ADDENDUM NO. 4

TO: Contract Documents for Construction of Central Avenue Flood Control Improvements - A FEMA Funded Project - Oracle Project No. 1002549

This Addendum No. 4 modifies the base bid schedule and corrects and clarifies the plans and specifications. Changes to project plans on attached sheets are shown clouded.

S 27/29

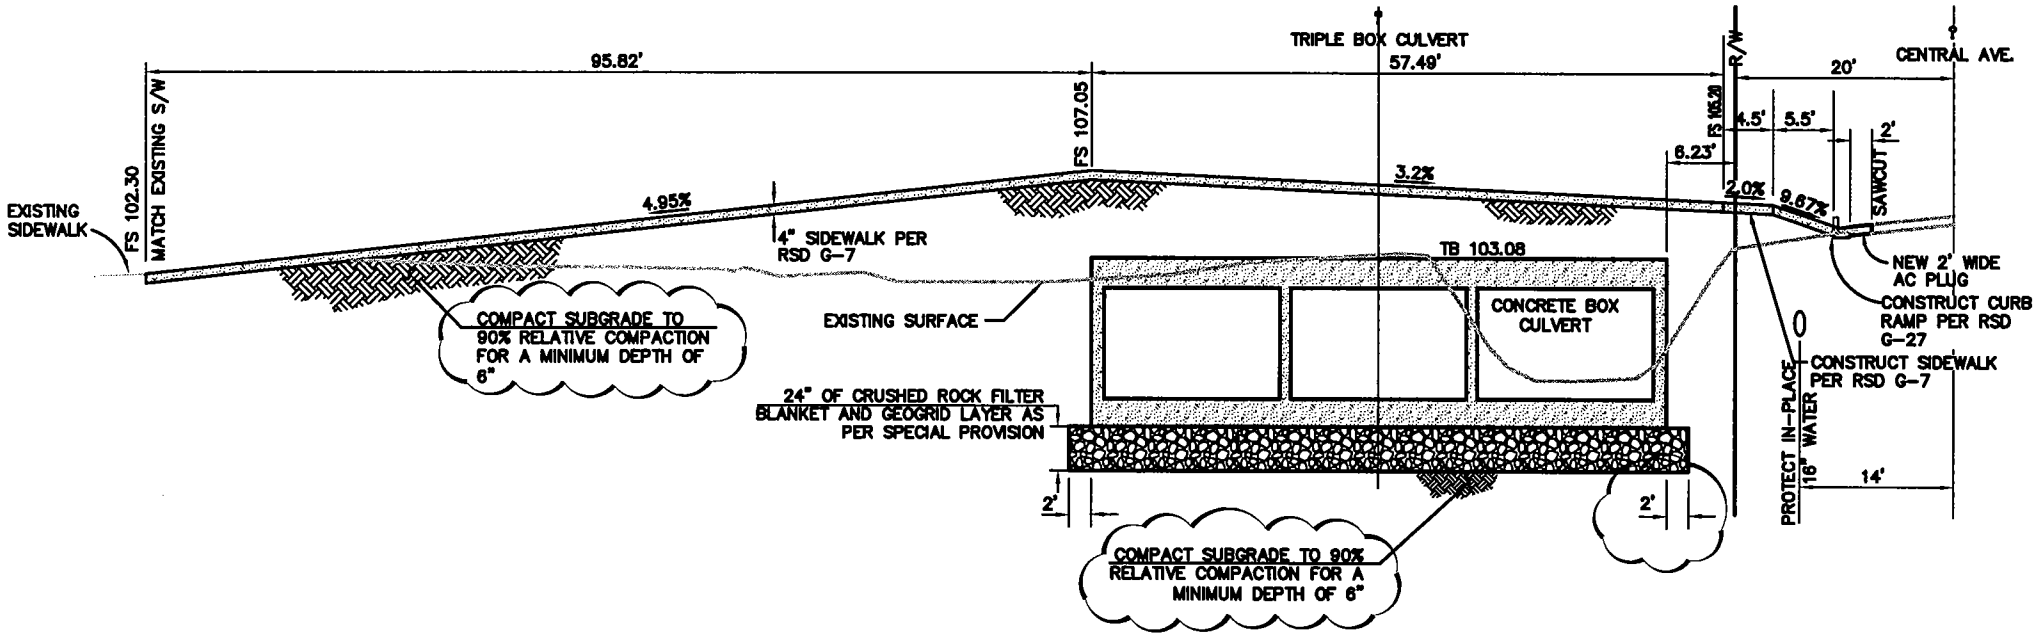
11. On sheet 7 of the project plans, replace Sections M, O, Q, R and S with attached Sections M (Addendum No. 4), O (Addendum No. 4), Q (Addendum No. 4), R (Addendum No. 4) and S (Addendum No. 4), respectively.

REVISED CROSS-SECTION FOR 6' WIDE CONCRETE ACCESS WALK ON SHEET 7

N
23
38
27

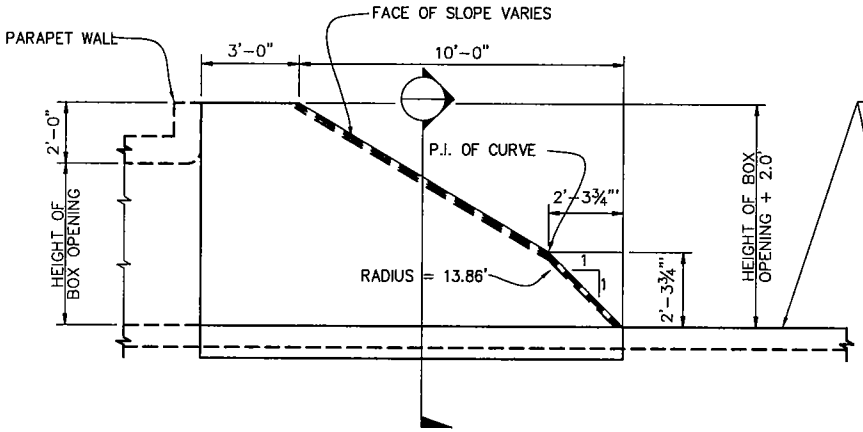
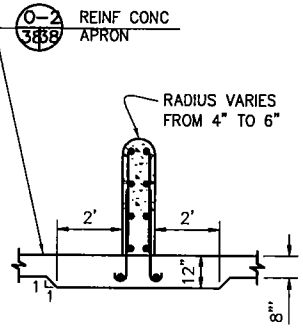
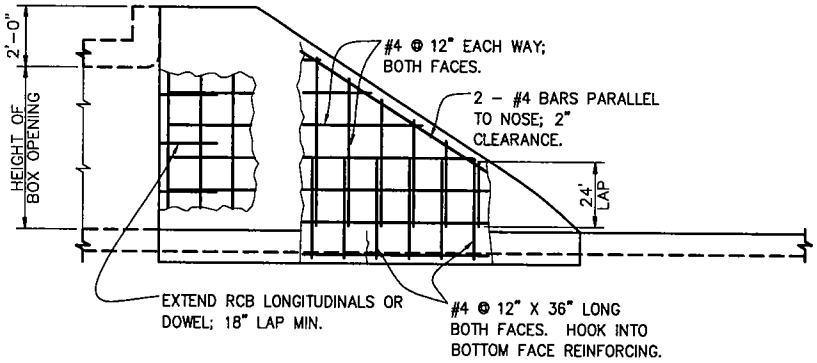
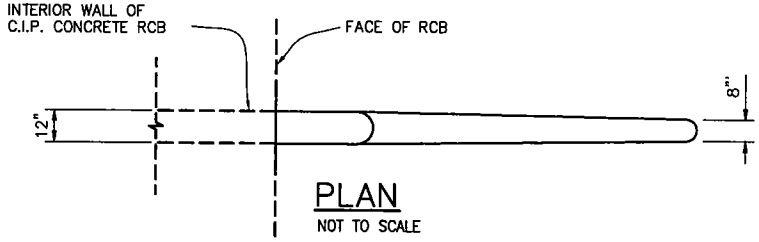
23. On sheet 38 of the project plans, replace Detail N with attached Detail N (Addendum No. 4).

UPDATED DEBRIS NOSE DETAIL ON SHEET 38

W 22 ADD

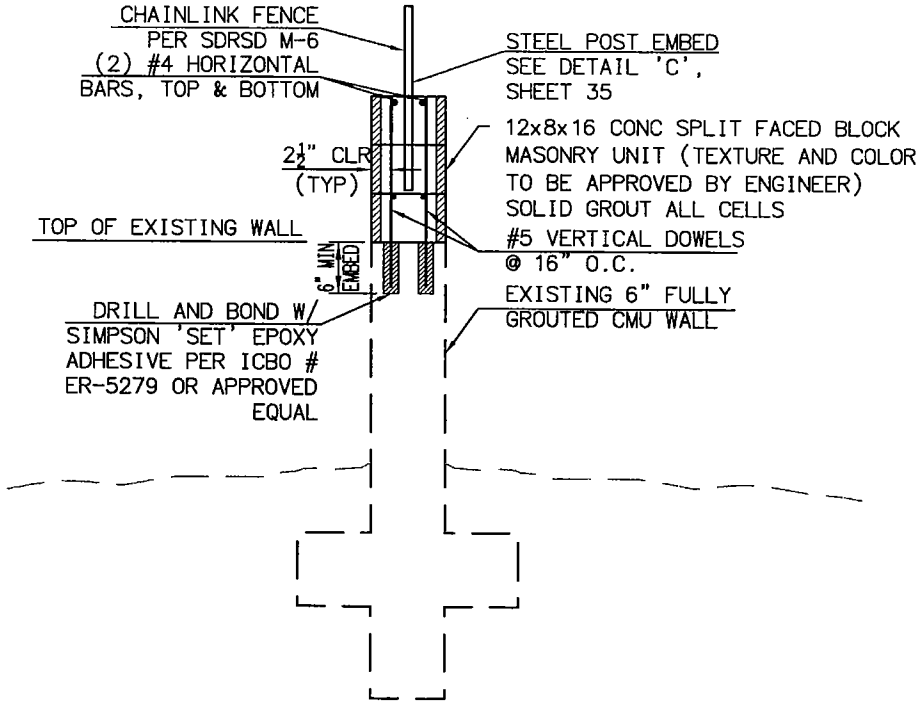
a) In the WALL DATA TABLE on the left side of the sheet, change the note for No. 22 to read, "CMU BLOCK RETAINING WALL EXTENSION PER DETAIL W (ADDENDUM NO. 4)".

b) Add attached Detail W (Addendum No. 4).

ADDITIONAL DETAIL TO PLAN SET THAT APPLIES TO WALL SECTION 22 ON SHEET 22

X / 23 ADD DEBRIS NOSE CONNECTION TO DAWSONIA RCB

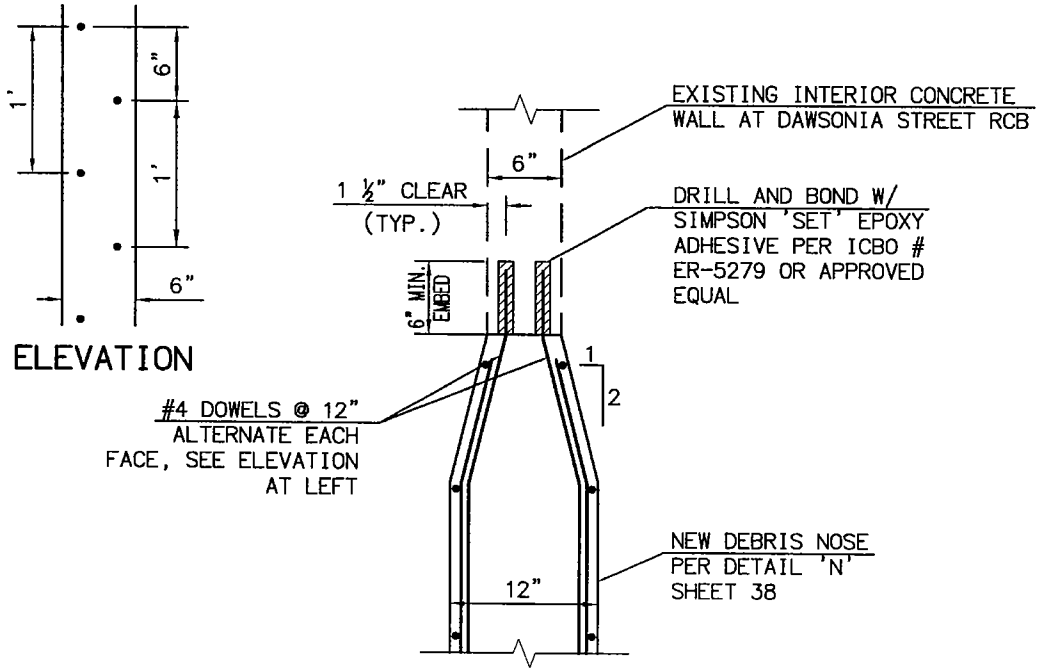
a) At "CONSTRUCTION NOTES:", At the end of Note 13, add the phrase, "AND CONNECT DEBRIS NOSE TO EXISTING RCB PER DETAIL X (ADDENDUM NO. 4)"

b) Add attached Detail X (Addendum No. 4).

ADDITIONAL DETAIL TO PLAN SET FOR DEBRIS NOSE CONNECTION TO EXISTING RCB IN DAWSONIA STREET ON SHEET 23

YY 18 ADD

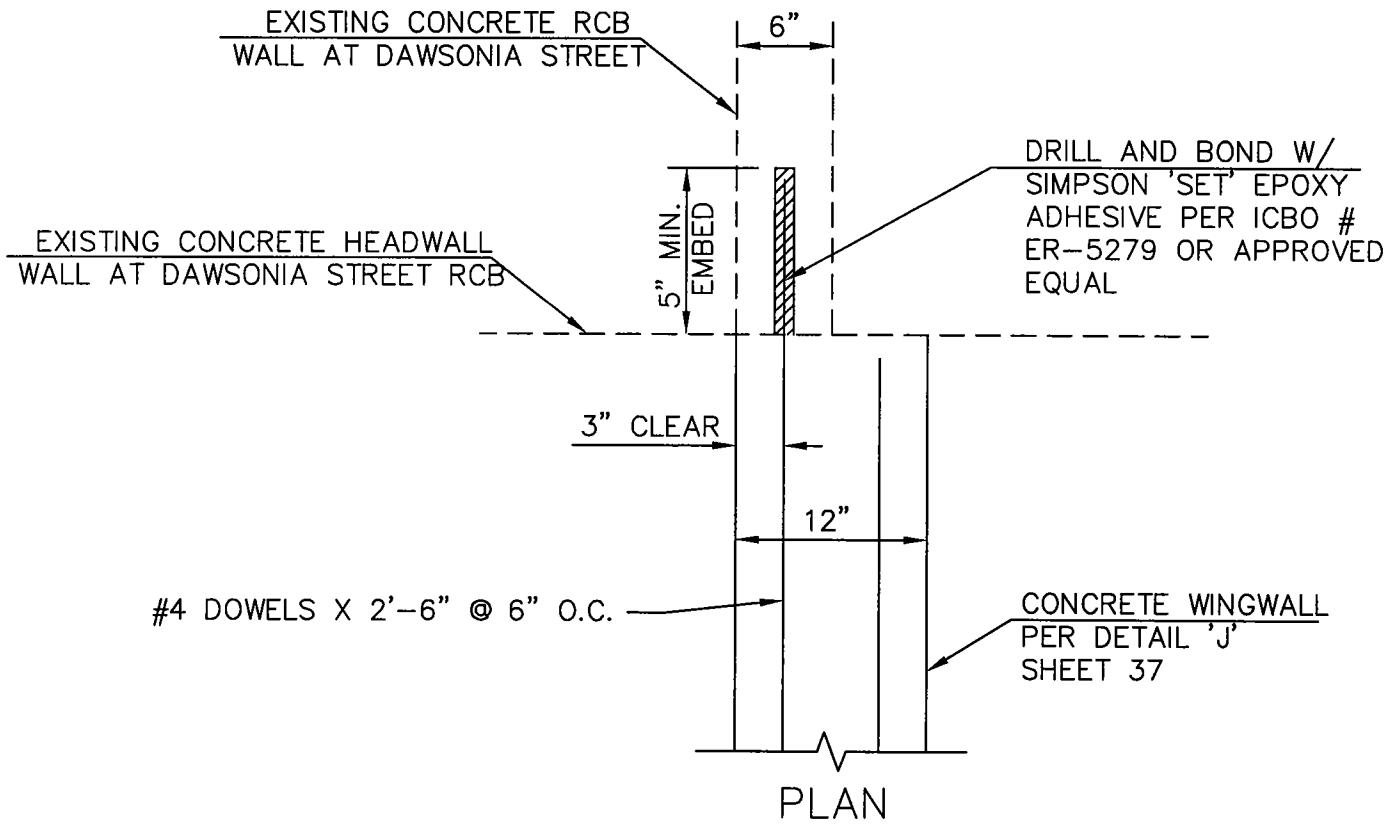
" (10) MAKE CONNECTION TO EXISTING RCB PER DETAIL YY (ADDENDUM NO. 4)"

b) In the top left corner of the Flood Wall Plan View, next to "(2)", add " (10)".

c) Add attached Detail YY (Addendum No. 4).

ADDITIONAL DETAIL TO PLAN SET FOR CIP RETAINING WALL CONNECTION TO EXISTING RCB IN DAWSONIA STREET ON SHEET 18

Z / 20ADD SOUTH WINGWALL CONNECTION TO DAWSONIA RCB

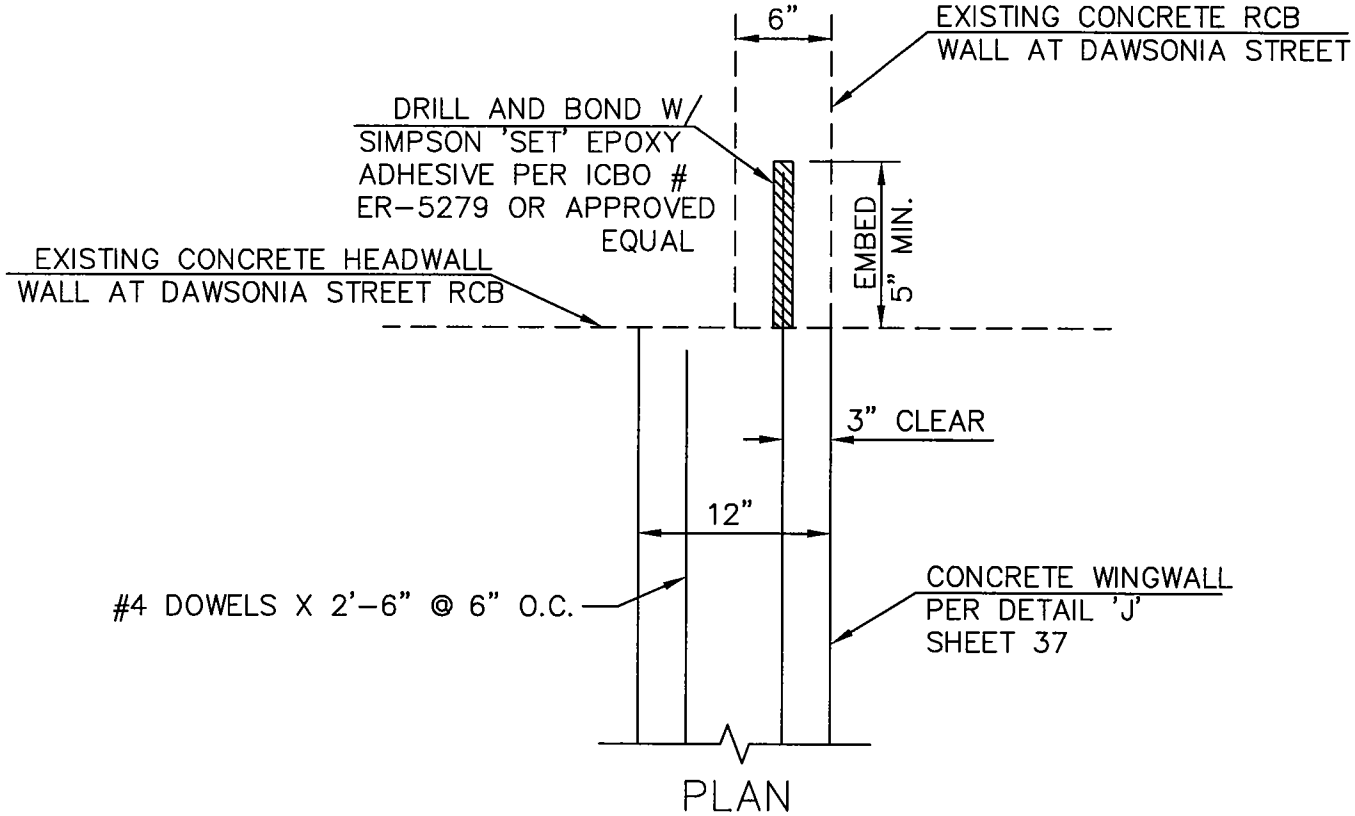
" 10 MAKE CONNECTION TO EXISTING RCB PER DETAIL Z (ADDENDUM NO. 4)"

b) In the top left corner of the Wall Plan View, just above '2", add " 10 "

c) Add attached Detail Z (Addendum No. 4).

ADDITIONAL DETAIL TO PLAN SET FOR CIP RETAINING WALL CONNECTION TO EXISTING RCB IN DAWSONIA STREET ON SHEET 20

TRIPLE BOX CULVERT
PLAN VIEW (PORTION)

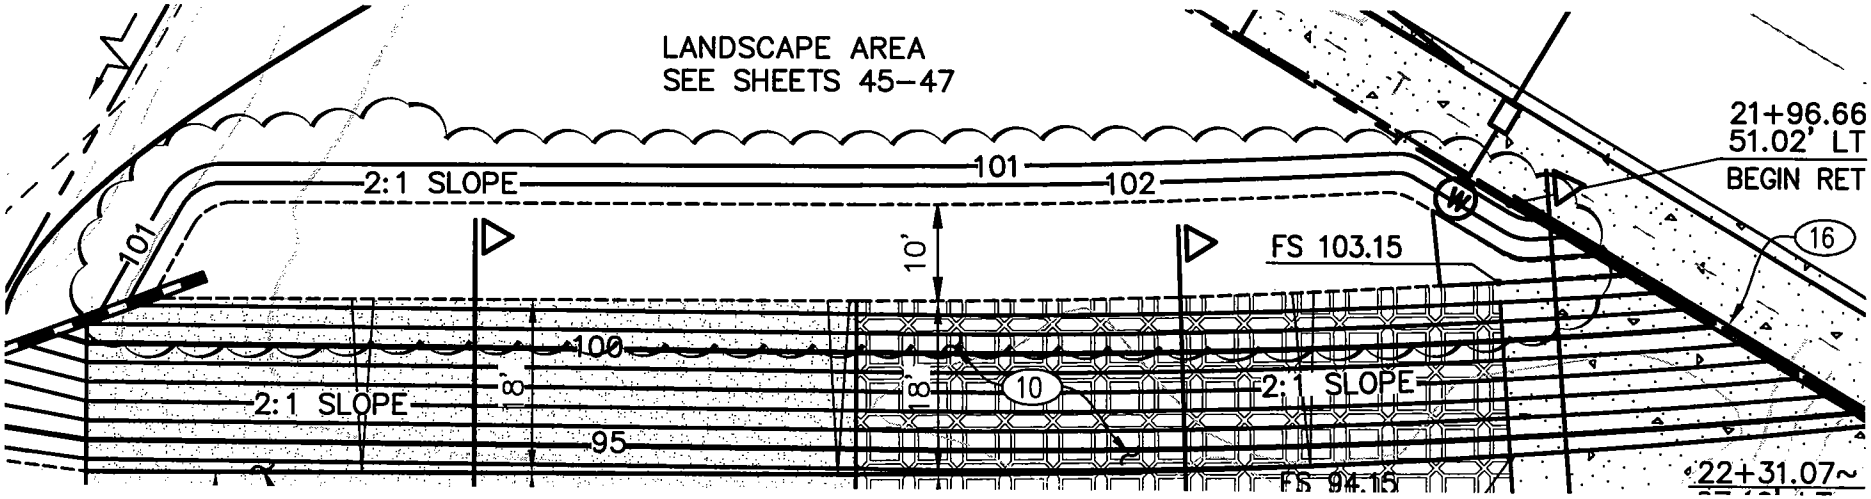
21. On sheet 26 of the project plans, replace a portion of the plan view with that shown on attached plan view entitled "TRIPLE BOX CULVERT PLAN VIEW (PORTION) (ADDENDUM NO. 4)".

REVISED GRADING AT TOP OF CHANNEL SLOPE ON SHEET 26

TYPICAL SECTION

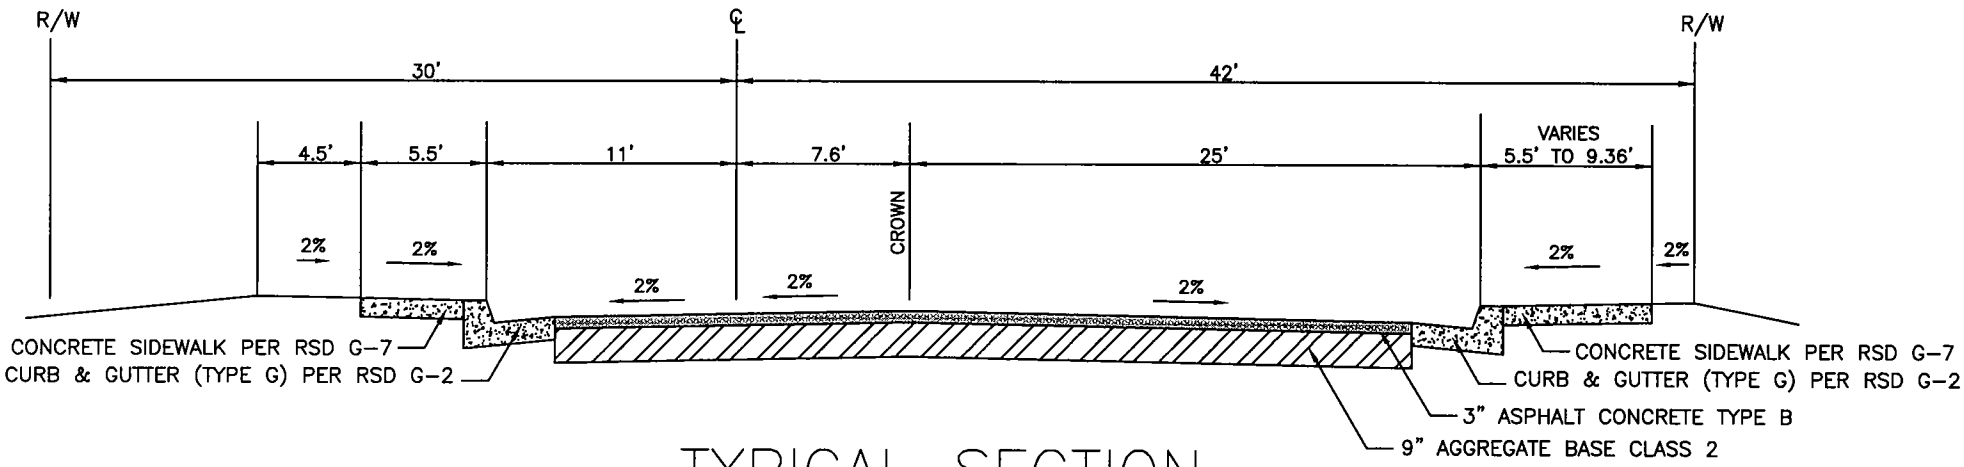
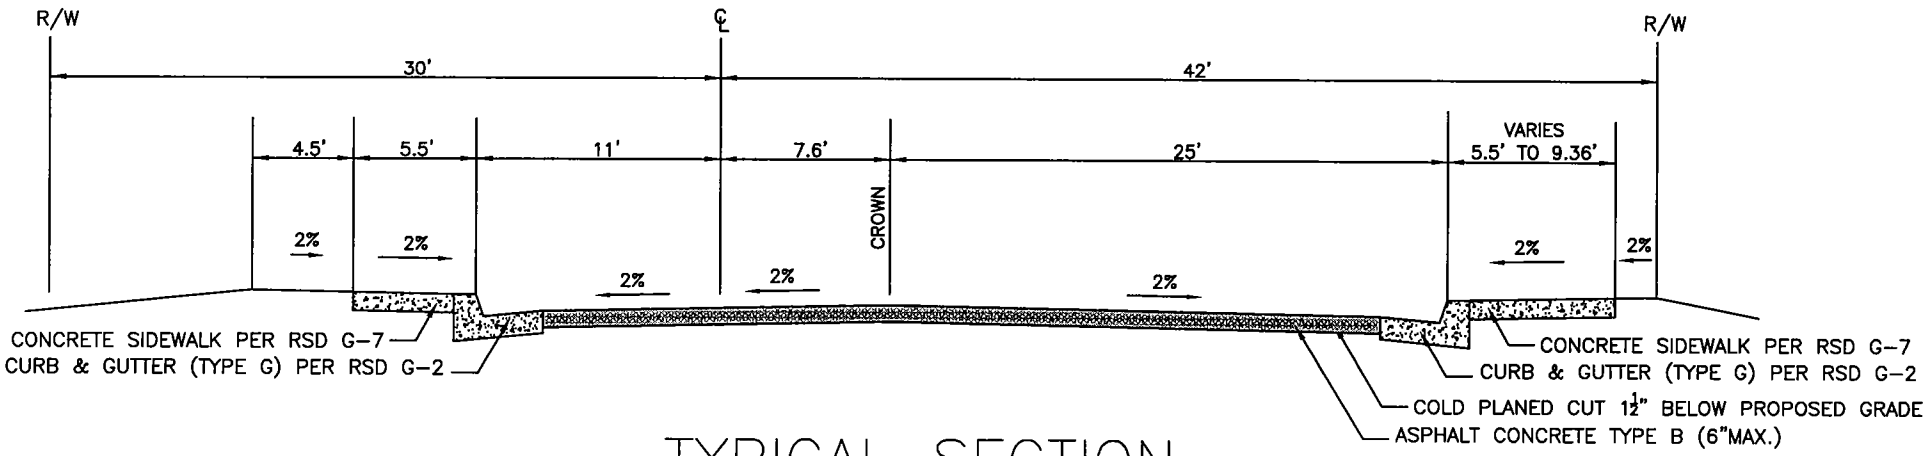
"The existing pavement on Central Avenue shall be cold planed for the full width of the road between Station 11+80 and Station 12+40 and between Station 14+27 and Station 14+82. The pavement shall be sawcut at Station 12+40 and at Station 14+27. The existing pavement shall be removed between Station 12+40 and Station 14+27.

25. Add attached Sheet 1 of 3 – Sheet 3A (Addendum No. 4), Sheet 2 of 3 – Sheet 3A (Addendum No. 4) and Sheet 3 of 3 – Sheet 3A (Addendum No. 4) to the project plans.

PIPE PROTECTION CONCRETE SLAB
(FROM STA 13+00 TO STA 14+00)

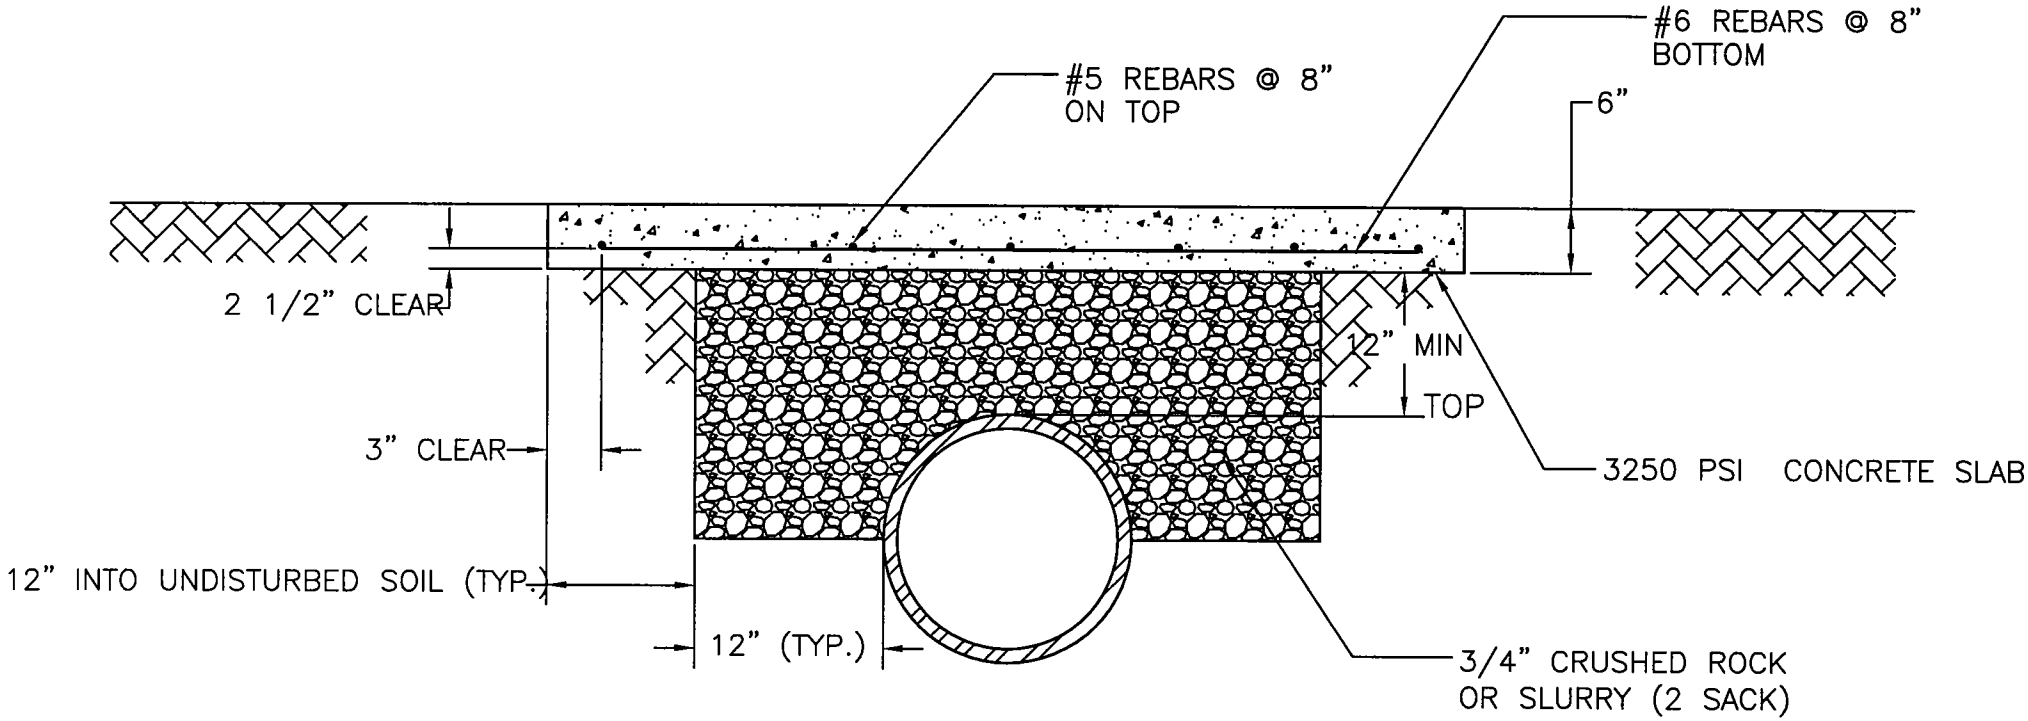
a) At the end of the first sentence of the first paragraph, add the phrase, "except that the bedding requirements under the reinforced concrete box culvert shall also conform to the concrete slab pipe protection detail on sheet 13 of the project plans."

c) Add attached detail entitled "PIPE PROTECTION CONCRETE SLAB (FROM STA 13+00 TO STA 14+00) [ADDENDUM NO. 4]" to sheet 13 of the project plans.
